# **Product Change Notification / KSRA-13AKNI696**

CCB 4440 Final Notice: Qualification of MMT as an additional assembly site for selected MTCH112, MTCH810 and PIC12xxxx device families available in 8L DFN (3x3x0.9mm) package.

# CCB 4440 Pre and Post Change Summary Lead Frame Comparison PCN#: KSRA-13AKNI696

# Lead frame comparison 8L DFN (3x3x0.9mm)

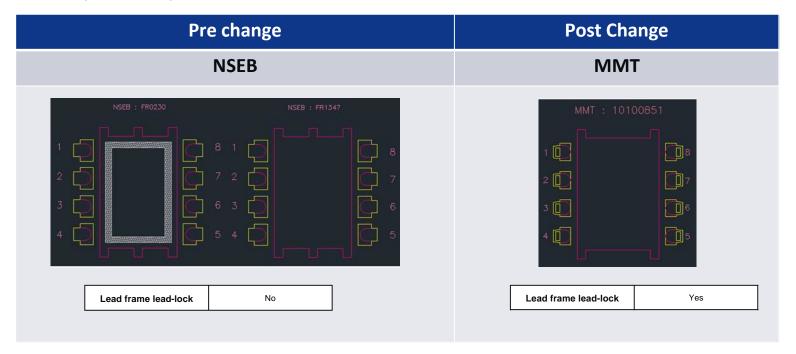
**Pre Change:** Assembled at NSEB using gold (Au) or palladium coated copper wire with gold flash (CuPdAu) bond wire, 8600 die attach material, EFTEC-64T lead frame or C194 lead frame material, Ag DAP surface prep or Bare Cu DAP surface prep and without lead lock lead frame.

**Post Change:**Assembled at NSEB using gold (Au) or palladium coated copper wire with gold flash (CuPdAu) bond wire, 8600 die attach material, EFTEC-64T lead frame or C194 lead frame material, Ag DAP surface prep or Bare Cu DAP surface prep and without lead lock lead frameorAssembled at MMT using palladium coated copper wire with gold flash (CuPdAu)

bond wire, 3280 die attach material, C194 lead frame material and Bare Cu DAP surface prep and with lead lock lead frame.
